SUBJECT: AMAX - Construction/Modification Permit Application

Pursuant to our meeting of December 21, I would like to confirm the project changes that relate to the AMAX Phosphate Feed Preparation Plant Baghouse Modification Permit (FDER Number AC 29-46069). There are three primary changes in the original plan. The first, as presented to you in the above-mentioned meeting, involves the replacement of the present Mikro-Pulsaire unit 37-8-100 (FDER Permit Number AO 29-6318) with a new 24,300 cfm baghouse and several new collection points. The difference between the new approach and the one presented in the modification permit involves the separation of a portion of the process area. This eliminates some of the dust collection points originally included in the 24,300 cfm baghouse system. The request for change was accompanied by revised permit application pages (for AC 29-46069).

PROJECT: Feed Prep Plant  
Baghouse

Due to the acceptance of an improved engineering proposal from Case Engineering, Inc., revisions in the original application of modification (construction) Permit No. AC 29-46069 were made necessary. We are submitting the revised application in its entirety with the follo

FEED PREP AREA  
 DUST PARTICULATE EMISSION COLLECTION SYSTEM (DRY)

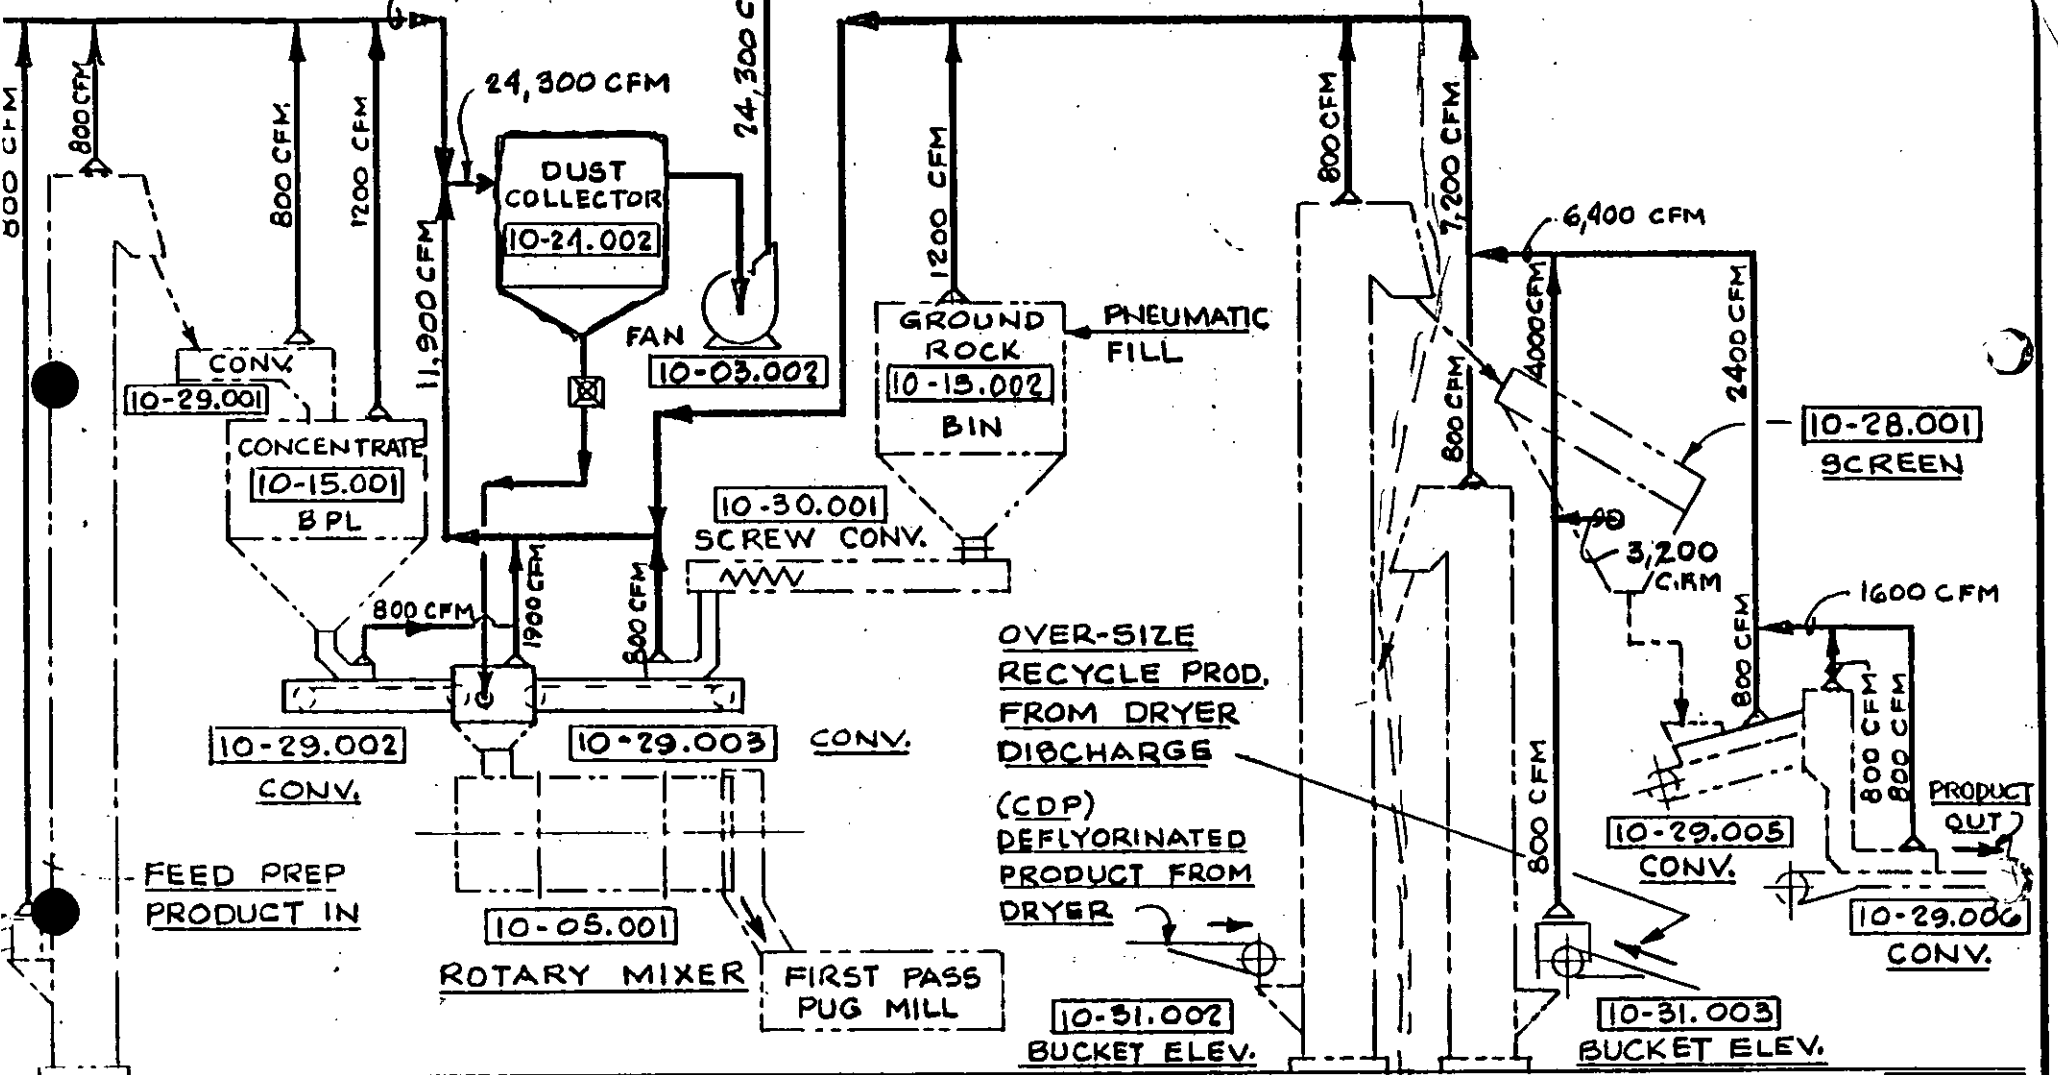
I have also attached some of the old correspondence including the original permit. On the diagram I have shown the split as now proposed.

changed to 24,300 ACFM ← 7,500 ACFM → Baghouse

The second change involves the installation of a new 7,500 cfm baghouse that will replace the present Mikro-Pulsaire unit 25-8-100 (FDER Permit Number AO 19-6318). The baghouse will control the portion of the Feed Preparation System that was removed from the 24,300 baghouse. The reason for the separation of the two systems was to improve the fugitive dust capture, to design for the loss of air flow from duct wall build-up, and to allow operations the flexibility of being able to operate either system independently of the other. This second installation will be submitted in the form of an additional modification permit and will be treated as a totally separate system from the 24,300 baghouse covered by modification permit AC 29-46069.
